Appendix 3 – Transportation Analysis (Gray Matter Limited)

Proposed Private Plan Change 35 – Te Awamutu Large Format Retail Centre

05_233

WAIPĀ PRIVATE PLAN CHANGE 35 (PPC 35) – TRANSPORT REVIEW

Figure 2: Existing access locations and transport assessment referencing

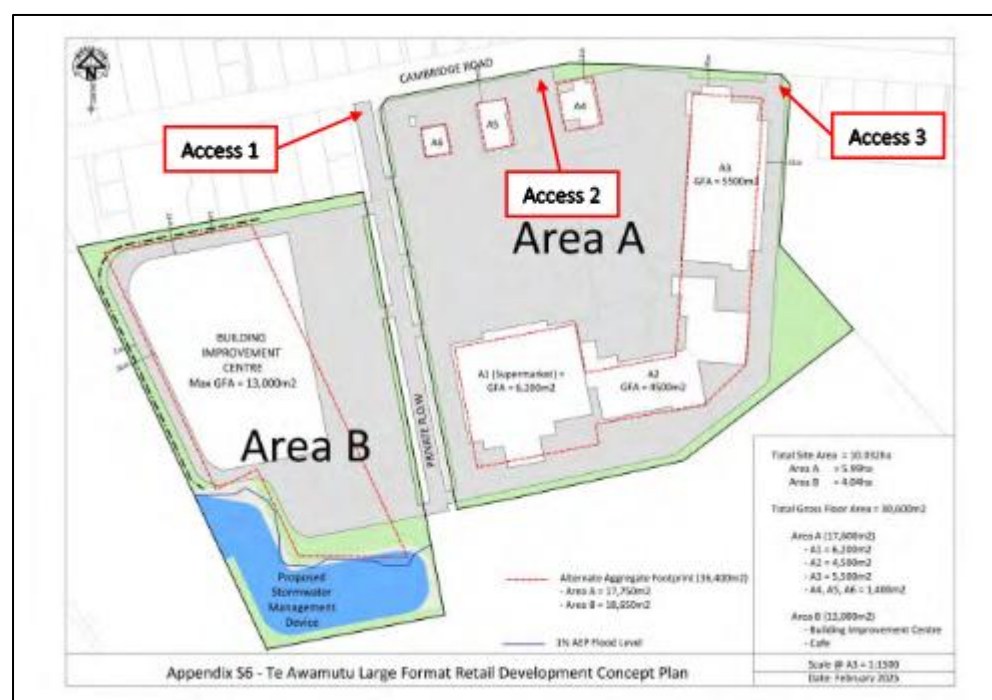
As shown on Figure 1 above, the concept plan shows the proposed vehicle crossings to Area B would be located nearly opposite the existing vehicle crossings to Area A. This results in a crossroads type of arrangement which is undesirable as it increases the number of conflict points and increases the likelihood of confusion between drivers.

While through movements from Area A to Area B via vehicle are likely to be infrequent the risk of 90-degree impact crashes would be avoided by increasing the vehicle crossing separation. The District Plan does not specify the minimum separation between vehicle crossings located on the opposite side of the road, we recommend that the concept layout be updated to ensure the proposed vehicle crossings are located at least 20m away from the existing vehicle crossings.

Figure 4: DSI Risk Urban 3 Leg T intersection⁷ (future volumes on Cambridge Road)

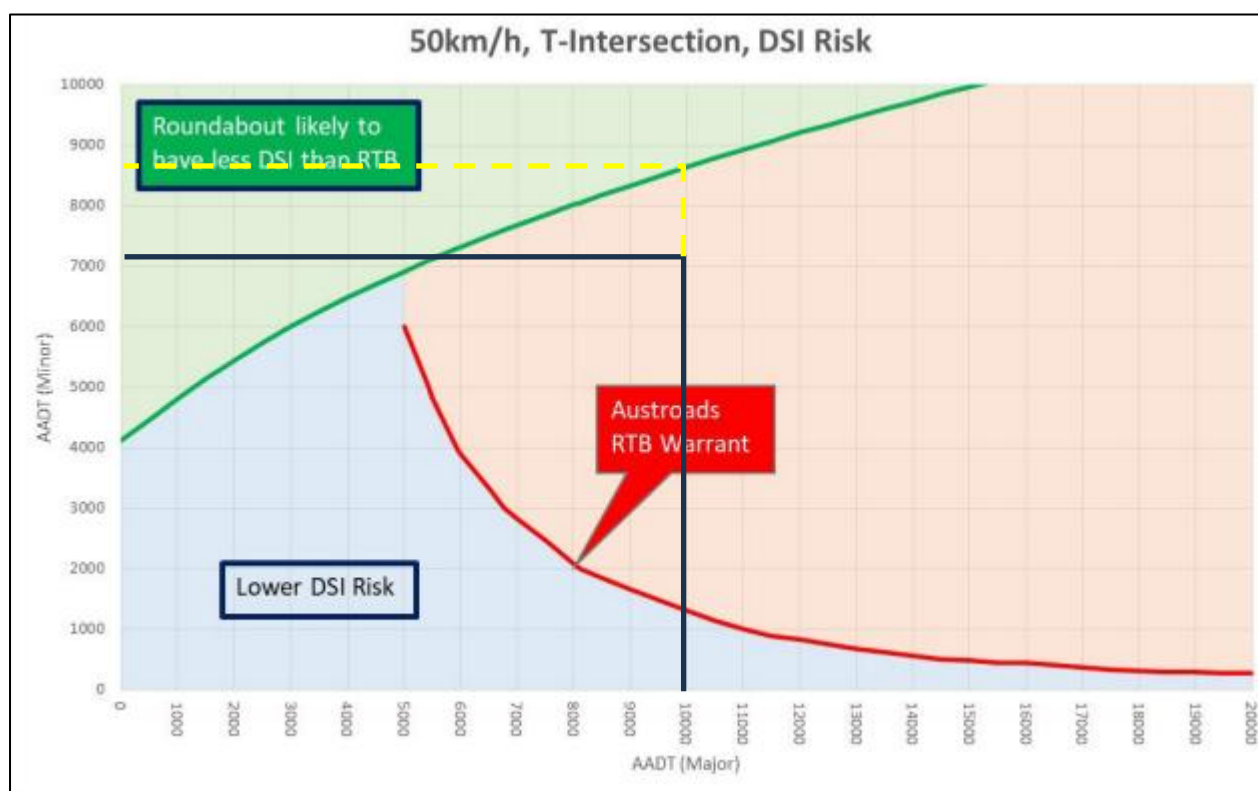
Using the NZTA State Highway Provisions DSI risk chart and 10,000 veh/day on Cambridge Road, the minor road traffic volumes would need to be around 8,500-9,000 veh/day for a roundabout to have greater DSI savings than a priority-controlled intersection (shown as yellow dashed line). Based on the expected trip generation of around 7,000 veh/day an intersection with a right turn bay is likely to have a lower DSI compared to a roundabout based on the NZTA guidance (blue lines in the figure below).

While a signalised intersection is not an option on this graph, the Guide states that “Larger (>250 vpd) urban development accessways which effectively create a T-intersection, Figure 8-3 below provides the approximate major and minor road AADTs in urban areas where the installation of a roundabout will likely provide the best outcomes in reducing DSI. For larger developments, the use of traffic signals may be appropriate depending on the mix of traffic and vulnerable user volumes.”

In principle we agree that traffic signals are the appropriate intervention for this location, given the traffic volumes and assessment against NZTA guidance for access provision in a 50km/h zone.

Figure 7: Access 1 concept layout

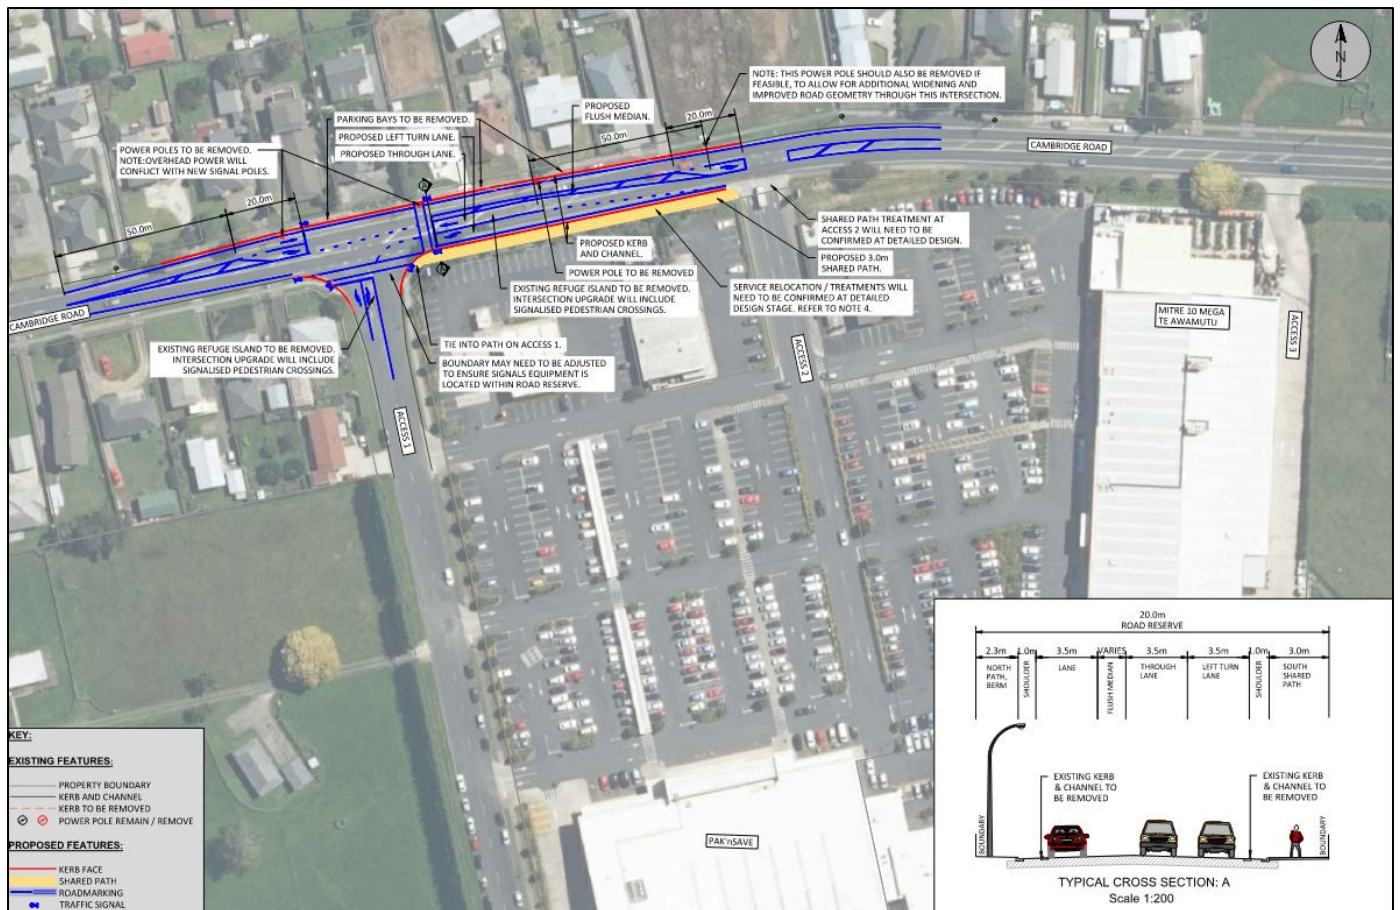
The proposed intersection includes separate through and right-turn lanes on the eastbound Cambridge Road approach and on the Access 1 approach. The concept plan shows only a single lane on the westbound Cambridge Road approach. In our view this limits the ability for signal optimisation. For example, it would not allow simultaneous operation of the westbound Cambridge Road left turn into Access 1 while vehicles are exiting Access 1. The absence of a dedicated left-turn lane means that a left-turn arrow cannot be used to hold traffic at the beginning of the pedestrian crossing phase, increasing the potential for a vehicle-pedestrian crash to occur.

In our view, a left turn lane is required to ensure safe and efficient operation of the intersection. Council have asked us to determine whether a modified intersection with left turn lane can be accommodated within the road reserve. Our concept plan for this layout is shown in the figure below (a larger version is provided at Attachment B).

The intersection is constrained and while a left turn lane can be accommodated it results in the following compromises:

- = Shared path is located against the boundary which results in safety issues at the Access 2. Visibility splays will need to be protected at Access 2
- = Narrowing/ removal of the flush median on Cambridge Road reducing space for vehicles turning right to access the development and properties on the northern side of Cambridge Road
- = Removal of parking bays on Cambridge Road
- = Reduced right turn capacity into Access 2 (shorter length of full width flush median)
- = Signal poles located within the footpath, reducing width of footpath.
- = Minimises the berm space on the northern side which reduces flexibility for Council to provide shared path on both sides of Cambridge Road in the future. Reduced separation between driveways and footpath.
- = Removal/underground of power poles to ensure signals equipment can be established (higher costs).

As demonstrated in the concept above accommodating a signalised intersection with a left-turn lane within the existing road reserve requires the Cambridge Road flush median to be narrowed. This reduces the effective storage length for vehicles right-turning into Access 2, increasing the risk of queues extending into the eastbound through lane.

Most vehicles arriving from the west are expected to use the signalised Access 1 intersection. However, if some vehicles turn right into Access 2 from Cambridge Road, the reduced storage length may require them to wait partly within the through lane. While undesirable, the concept design provides approximately 5.5 m from the centreline to the kerb, which should allow vehicles to pass at low speeds.

The reduced median width affects access to existing residential properties on the northern side of Cambridge Road. Vehicles turning right into these properties will need to wait in the through lane, rather than within the flush median, which is undesirable.

Retaining a 2.5–3.0 m flush median, while also providing the left-turn lane and shared path, would likely require widening on the southern side and encroachment into Area A. This indicates that the current road reserve may be

The final layout of the intersection will be subject to detailed design, safe system audit and Council approval. Further design development and consultation are required to identify a layout that provides an appropriate flush median to accommodate both retail and existing residential access, safely manages right-turn movements, and avoids queue spilling into the through lane, particularly given the uncertainty around future traffic demand at Access 2.

Figure 8: The Base Parade/Te Rapa Road boundaries

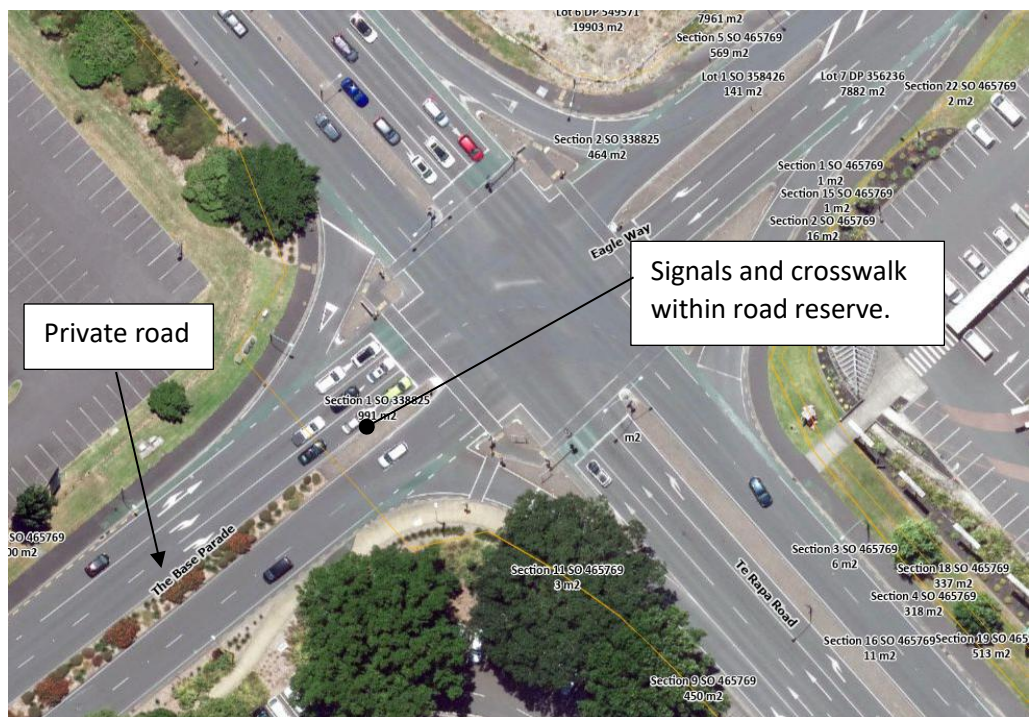
The Proponent's concept plan does not show the location of traffic signals and other equipment in relation to road reserve boundaries. Implementing signal equipment at the intersection may require the boundary at the private road to be adjusted so that the signal equipment and crosswalk are located within road reserve. For example, at The Base Parade in Hamilton the crosswalks and signals equipment are located within road reserve. We recommend that the boundaries are modified to ensure that signals equipment and the crosswalk is located within the road reserve.

We understand that the Proponent has discussed this with Foodstuffs and has proposed a plan provision which requires the Applicant (at the time of resource consent) to acquire any land required for the intersection upgrades by way of agreement with relevant landowners. Any land acquisition should be the responsibility of the Applicant and should not require Council to facilitate or undertake the acquisition.

Figure 9: Proposed concept layout and recommended changes

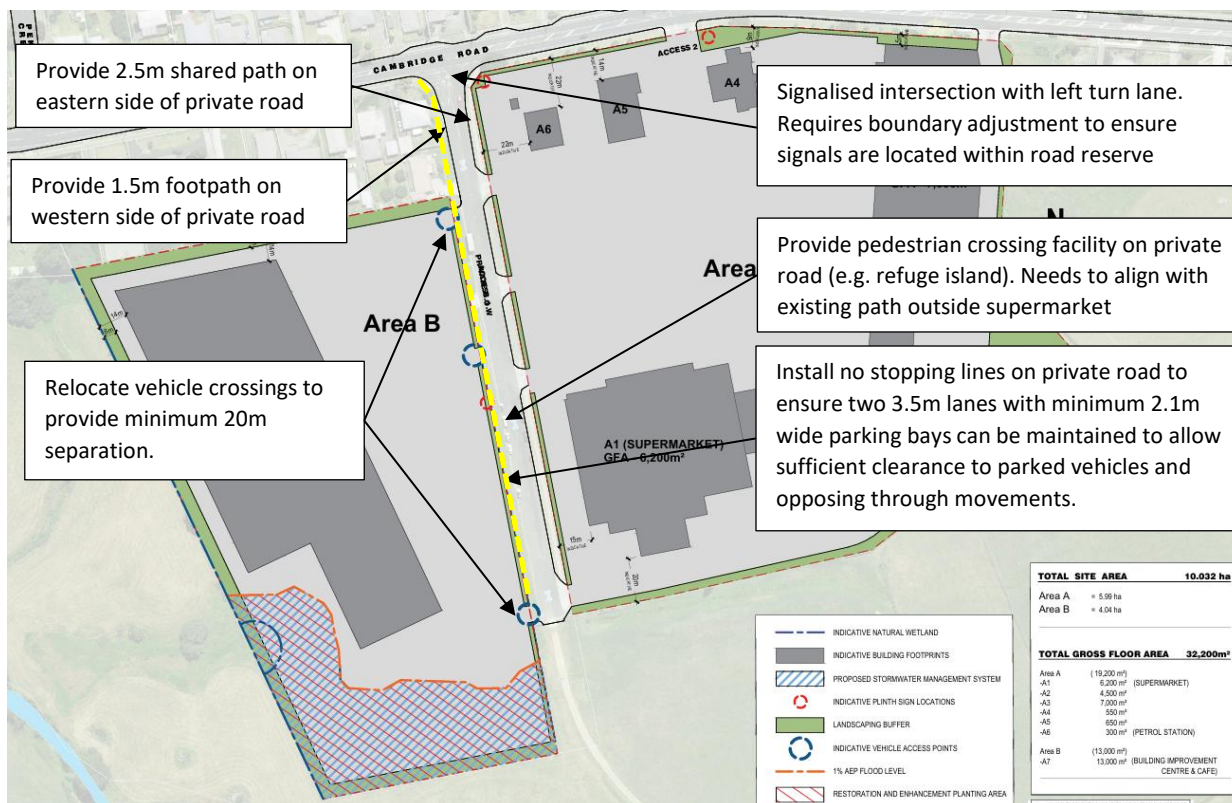
A summary of the proposed changes the concept plan is provided in the figure below.

- Include provision requiring a left-turn lane on the eastern Cambridge Road approach to Access 1.
- Include provisions requiring a safe pedestrian crossing on the private road between Area A and Area B, with adequate separation from existing and future vehicle crossings.
- Include provisions that ensure property boundary adjustments or land requirements necessary to accommodate traffic signals, pedestrian crossings, and the left-turn lane will be achieved. Any land acquisition should not be the responsibility of Council
- The concept plan should be updated to show the following changes:

- Changes to the private road boundary to ensure that signals equipment and the crosswalk are located within road reserve.
- Pedestrian crossing on the private road (e.g. refuge island or raised crossing).
- Shared path on the eastern side of the private road and footpath on the western side of the private road
- Provide a minimum 20m separation between vehicle crossings on the private road.
